RE: Hartford Avenue Rehabilitation from SE 22nd Stret to Cownie Soccer Complex
Activity ID: 06-2019-017

We are issuing Addendum No. 1 on the above-referenced project. This Addendum No. 1 modifies, supplements, or replaces information contained in the contract documents. This addendum is hereby made a part of the contract documents.

ADDENDUM NO. 1
ON
HARTFORD AVENUE FROM SE 22ND STREET TO COWNIE
SOCCER REHABILITATION
ACTIVITY ID 06-2019-017

1. Plan Sheet B.01 Replacement

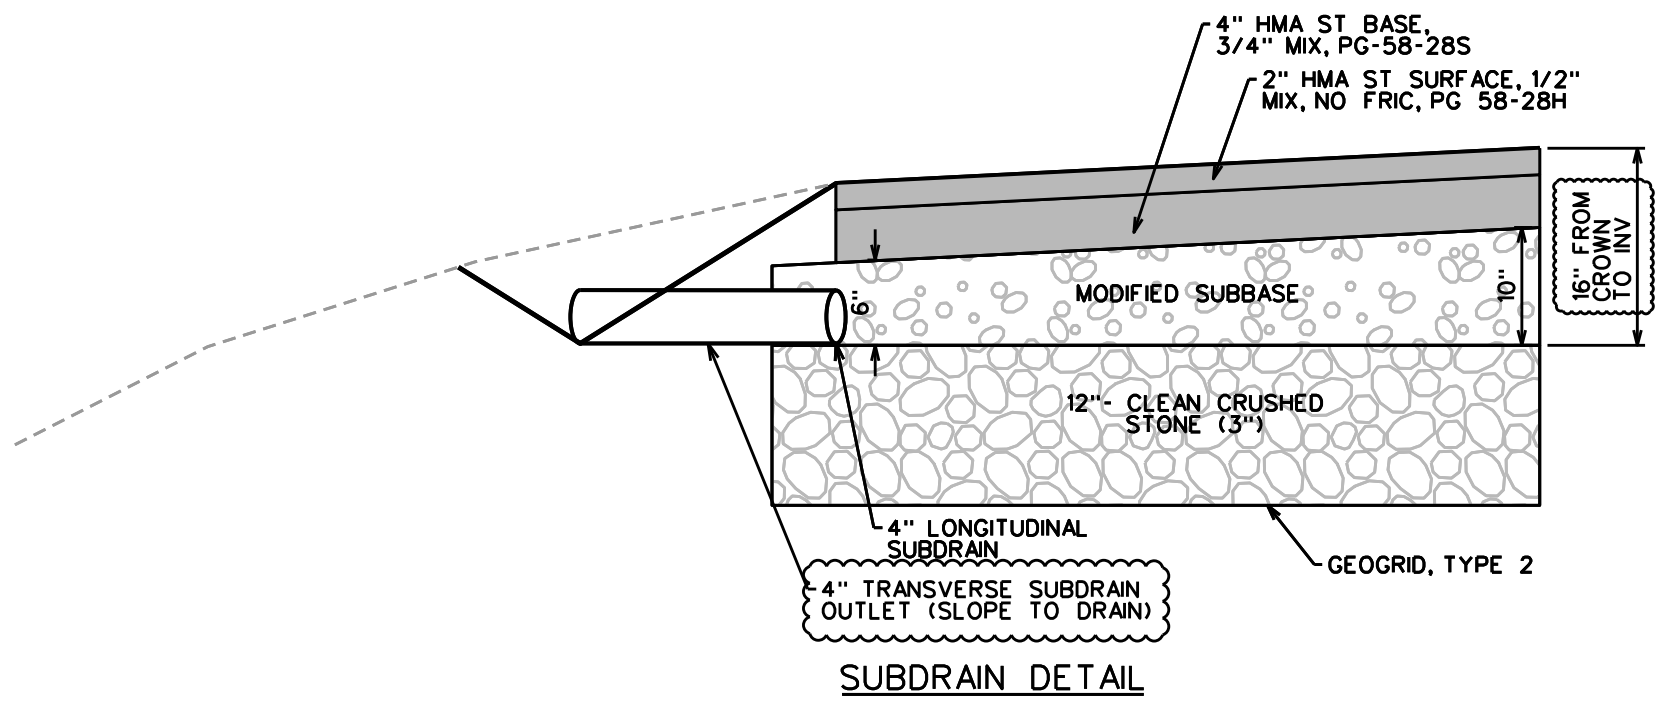
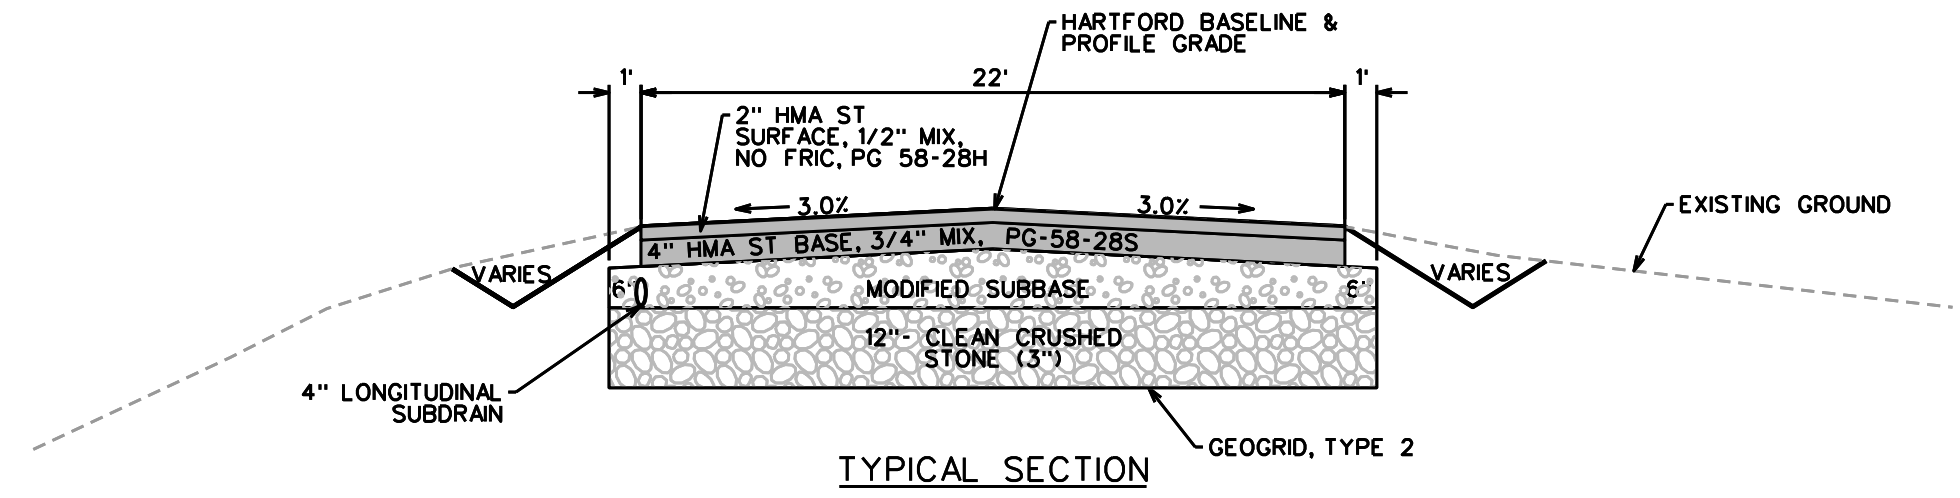
The attached Sheet B.01 replacement includes the following changes/clarifications to the 'Subdrain Detail'.

- A. Change distance from crown to subdrain invert/bottom of modified subbase layer to 16" instead of 1'.
- B. Clarified thickness of modified subbase to be 6" at the edge of the pavement and 10" at the crown.
- C. Clarified that the 4" transverse subdrain outlet is to be sloped to drain.
